Ohio Museum Complex HVAC
Lin Hall, The Ridges – Ohio University
Athens, Ohio

ADDENDUM 02

Addendum to the drawings and specifications for: **Ohio Museum Complex HVAC**

0104

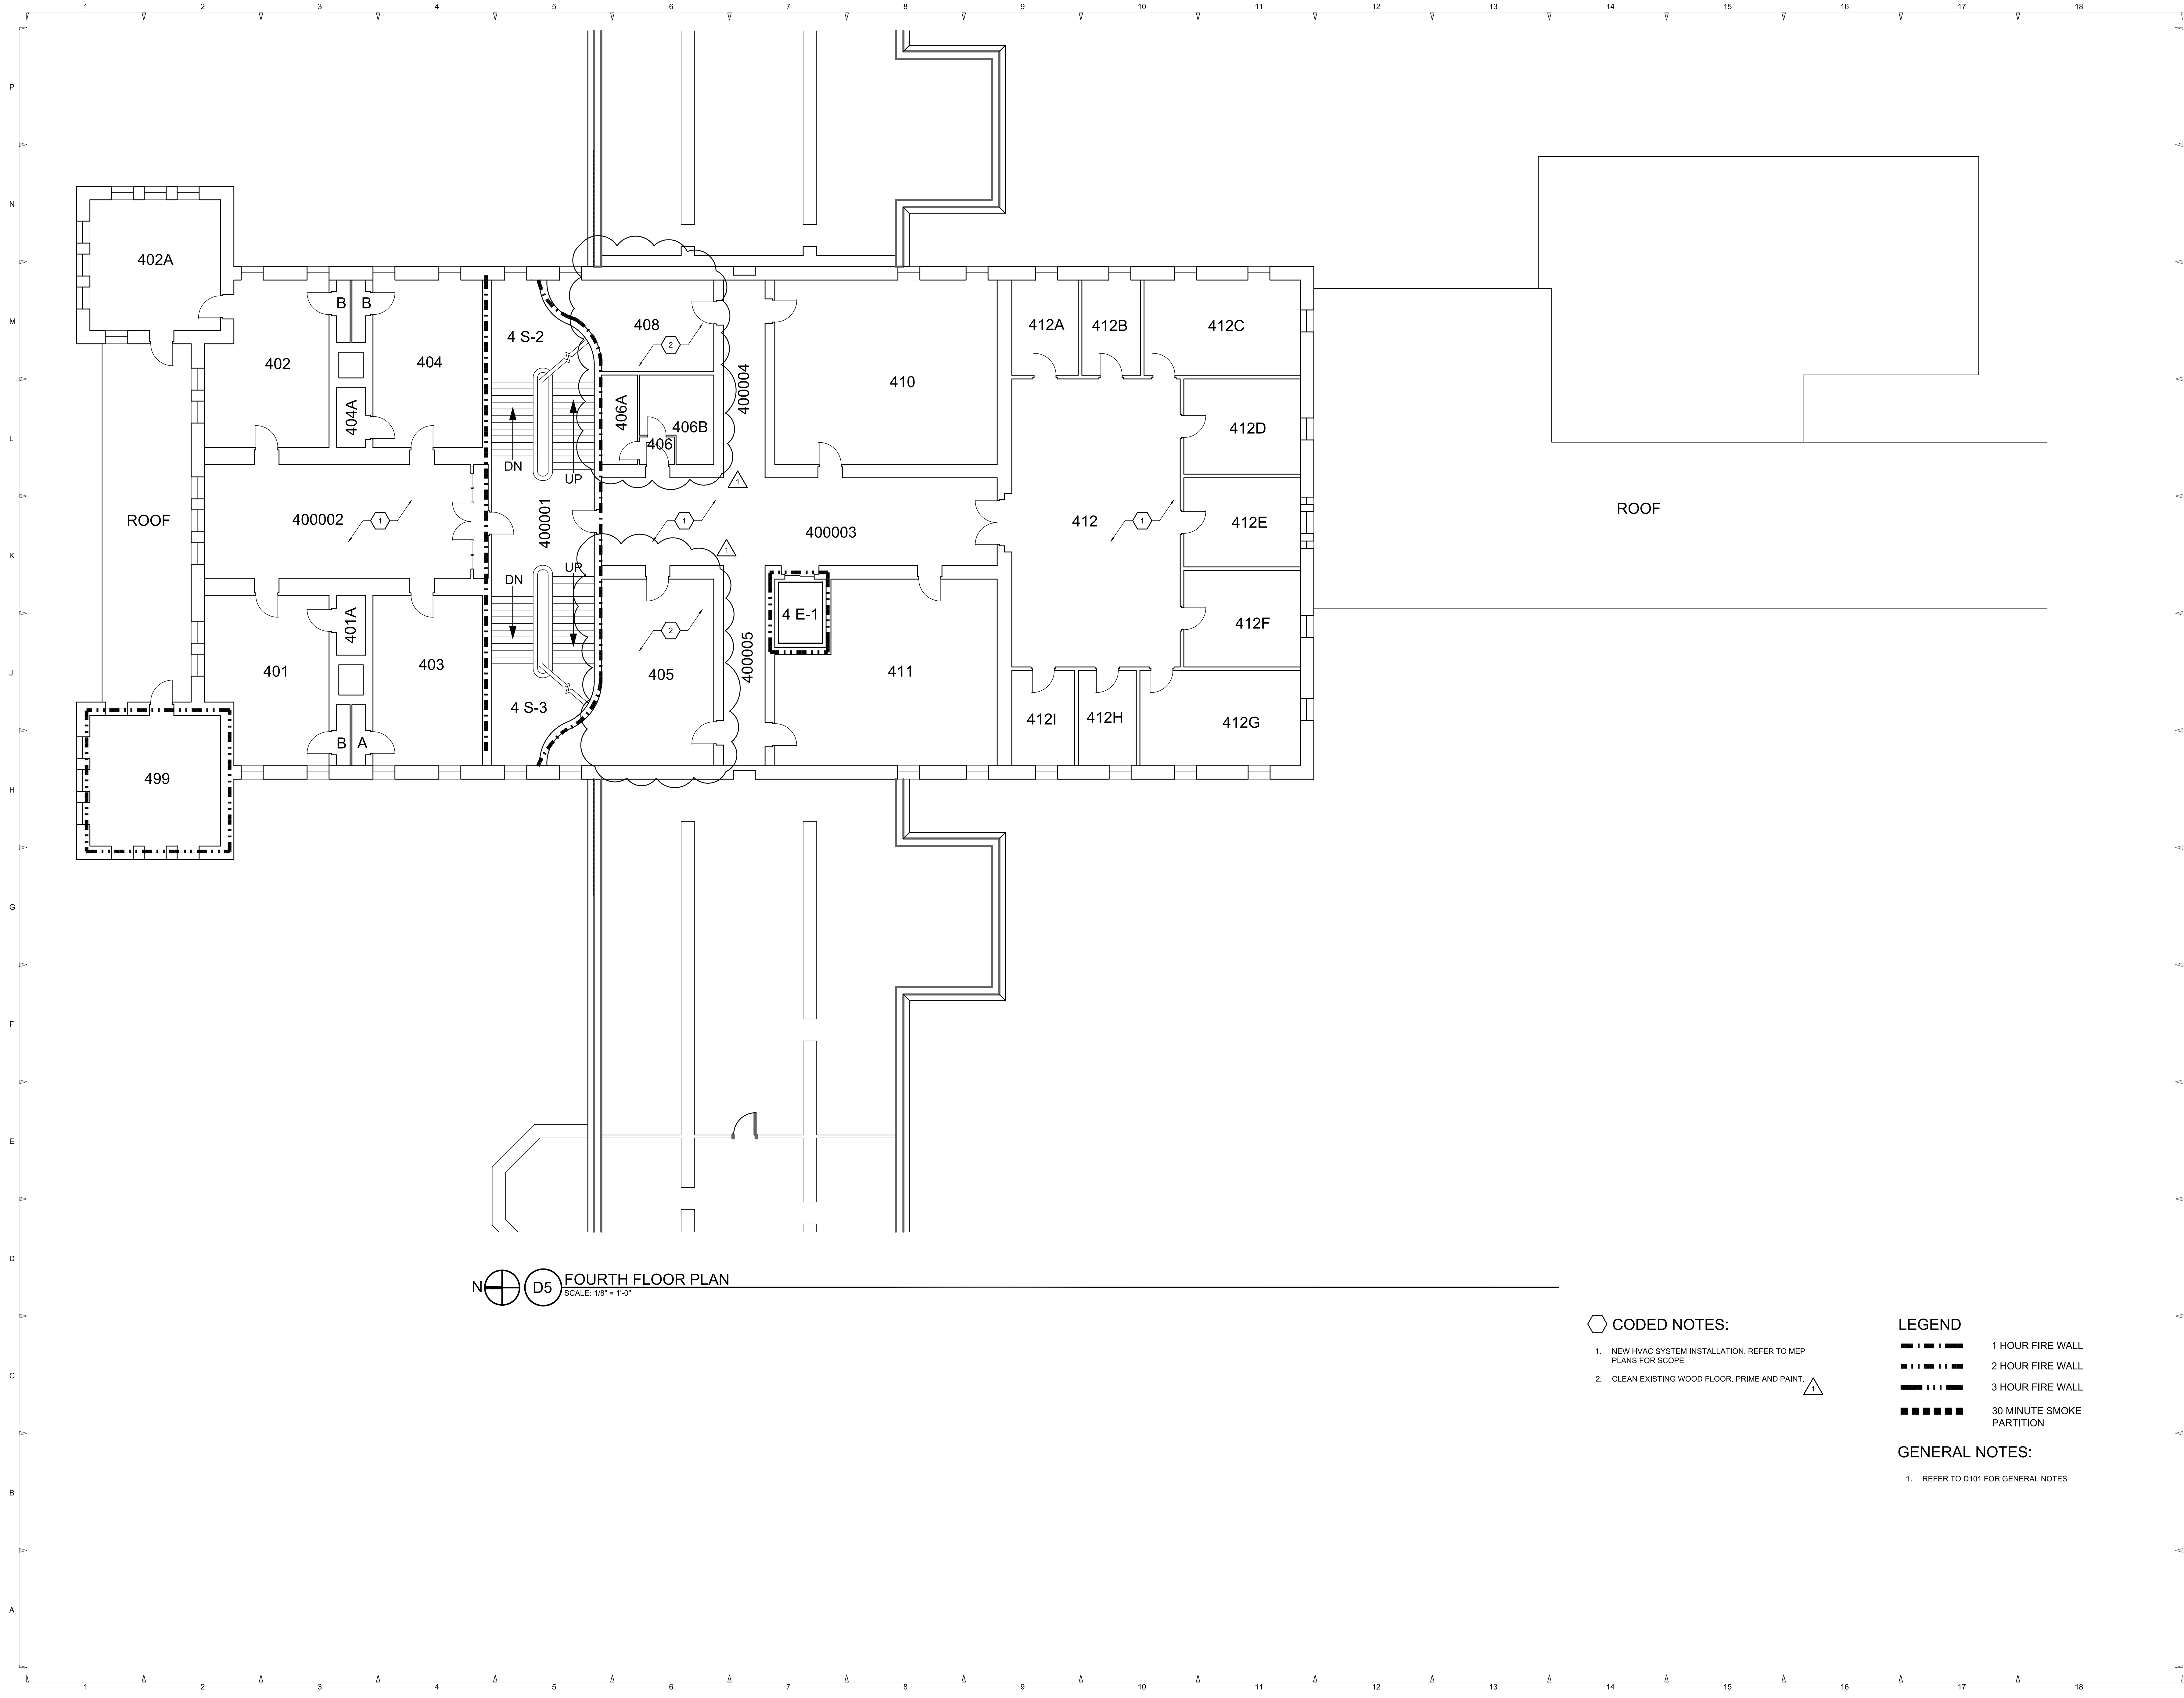
Mechanical room finish revisions.
3. Sheet D105

D105

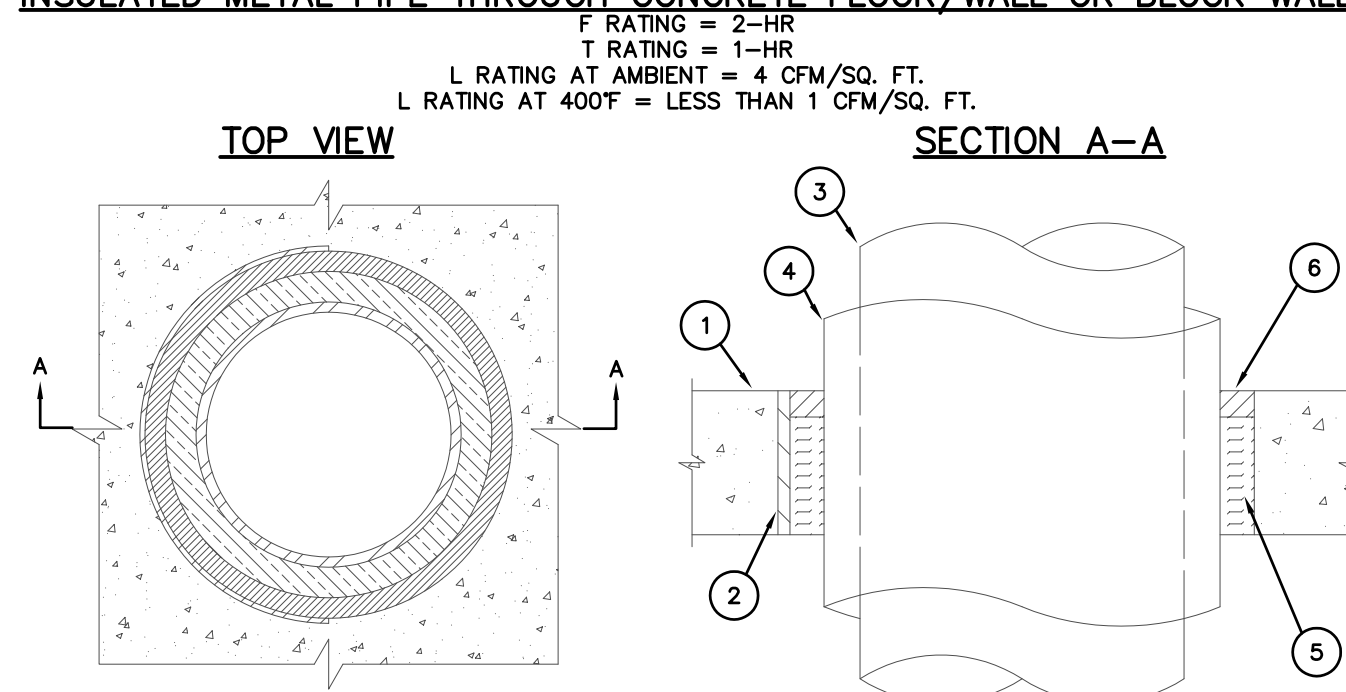
Mechanical room finish revisions.
